Particle Measurement Programme

Non-Exhaust Emissions Draft GTR Feedback Part 2

*Theo Grigoratos and
Barouch Giechaskiel*

04 OCT 2022

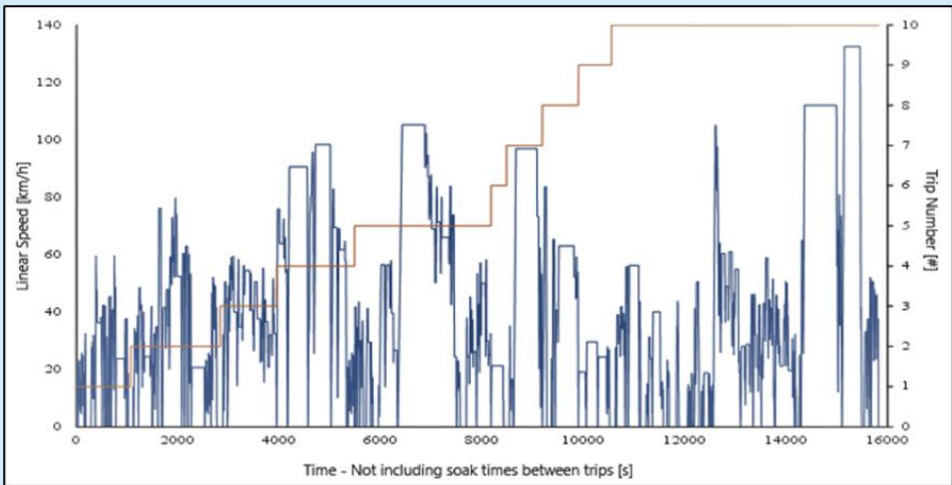
Excerpt from	Current text	Discussion Item – Proposed changes
3.	7.4.2 Brake enclosure design – Design specifications and (m)	<p>Current text:</p> <p>(l) Apply Computational Fluid Dynamics (CFD) to calculate the airspeed values at the nine positions of plane C. Carry out the computation at three different cooling airflow settings representing the minimum, 50 per cent, and the maximum of the operational airflow range of the test system. The simulation time shall be of sufficient duration to detect any instability in the airspeed pattern that may affect the airspeed values. Conduct the simulation without a brake assembly or a brake fixture installed. Airspeed at each position shall not vary by more than ± 20 per cent of the arithmetic mean of all measurements for a given flow;</p> <p>(m) It is strongly recommended that the testing facilities conduct physical measurements instead of the CFD simulations to verify the uniformity of the airspeed using the nine positions defined in points (k) and (l) of this paragraph;</p>	<p>It has been proposed by several stakeholders to mandate the experimental validation of the speed uniformity check and make the CFD optional. The proposed text would be:</p> <p>(l) Measure the airspeed values at the nine positions of plane C. Carry out the measurement at three different cooling airflow settings representing the minimum, 50 per cent, and the maximum of the operational airflow range of the test system. Conduct the measurement without a brake assembly or a brake fixture installed. Airspeed at each position shall not vary by more than ± 35 per cent of the arithmetic mean of all measurements for a given flow;</p> <p>(m) It is recommended that the testing facilities conduct also CFD simulations to verify the uniformity of the airspeed using the nine positions defined in points (k) and (l) of this paragraph. In this case, the simulation time shall be of sufficient duration to detect any instability in the airspeed pattern that may affect the airspeed values;</p> <p>JRC's suggestion: We agree in mandating the experimental validation of the speed uniformity. We think that the allowed flexibility shall increase to ± 35 per cent of the arithmetic mean of all measurements for a given flow to account for the measurement uncertainty. We recommend completely omitting the CFD measurement in this context as it does not add any value.</p> <p>Outcome: No objections received. Topic agreed for application.</p>

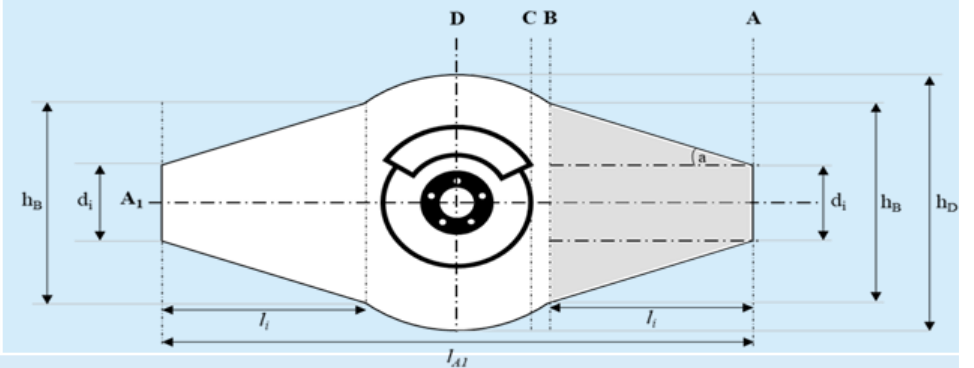
Excerpt from	Current text	Discussion Item – Proposed changes
18.	7.4.3 Dimensions	<p>(a) Design the brake enclosure symmetrically to plane A1. The length of plane A1 (IA1) represents the most extended length of the enclosure along the flow direction. Plane A1's length shall be between 1200 mm and 1400 mm ($1200\text{ mm} \leq IA1 \leq 1400\text{ mm}$);</p> <p>(b) Design the brake enclosure symmetrically to plane D. The length of plane D (hD) represents the longest distance (height) of the enclosure perpendicular to the flow direction. Plane D's height shall be between 600 mm and 750 mm ($600\text{ mm} \leq hD \leq 750\text{ mm}$);</p> <p>(c) The distance from plane C to plane D is as long as the radius of the largest market available brake on vehicles within the scope of this GTR (i.e. approximately 200-250 mm). ...;</p> <p>(d) Design the height at plane B (hB) such that the hB/hD ratio is always greater than 60 percent ($hB/hD > 60\%$). ...;</p> <p>(e) Design the outlet's transition length (li) and height (hb) such that they equate to the inlet's transition length (li) and height (hb);</p> <p>(f) The inlet and outlet diameters (di) shall equal to the diameter of the duct in the sampling tunnel as specified in paragraph 7.5;</p> <p>(g) The maximum axial depth of the brake enclosure at plane D (parallel to the brake rotation axis) shall be between 400 mm and 500 mm.</p>	<p>One stakeholder proposed a diamond-shaped enclosure design with fixed dimensions. More specifically:</p> <p>(a) Proposal: 1380 – 1400mm. Alternatively 1180 – 1200mm;</p> <p>(b) Proposal: 580 – 600mm;</p> <p>(c) Proposal: 225mm +/- 5mm;</p> <p>(d) Proposal: hB/hD ratio = 1;</p> <p>(e) Proposal: li = 390 – 400mm. hb = 580 – 600mm;</p> <p>(f) Proposal: di = 200mm+/-5mm or 203,2mm+/-5mm;</p> <p>(g) Proposal: 590 – 600mm.</p>

JRC's suggestion/position: The topic has been discussed several times also at the PMP level. The vast majority of the stakeholders have agreed with the specifications and the flexibility allowed in the draft GTR for the enclosure design. Furthermore, the proposed values and shape has not been adopted, tested, or validated by any stakeholder.

One possible alternative would be to proceed with the approach already proposed in the draft GTR and add some recommendations for the length, height, and depth of the design. Setting recommendations for (a), (b), and (g) would also affect the other design points indirectly so there would be no need to recommend values also for points (d) and (e). This would result in more comparable designs for those who select to follow these recommendations. The text could read as follows: **(a) Design the brake enclosure symmetrically to plane A1. The length of plane A1 (IA1) represents the most extended length of the enclosure along the flow direction. Plane A1's length shall be between 1200 mm and 1400 mm ($1200\text{ mm} \leq IA1 \leq 1400\text{ mm}$). It is recommended to design an enclosure with a length close to 1300 mm;** **(b) Design the brake enclosure symmetrically to plane D. The length of plane D (hD) represents the longest distance (height) of the enclosure perpendicular to the flow direction. Plane D's height shall be between 600 mm and 750 mm ($600\text{ mm} \leq hD \leq 750\text{ mm}$). It is recommended to design an enclosure with a height close to 650 mm; ...;** **(g) The maximum axial depth of the brake enclosure at plane D (parallel to the brake rotation axis) shall be between 400 mm and 500 mm. It is recommended to design an enclosure with an axial depth close to 400 mm.** Would such an approach be acceptable for the group?
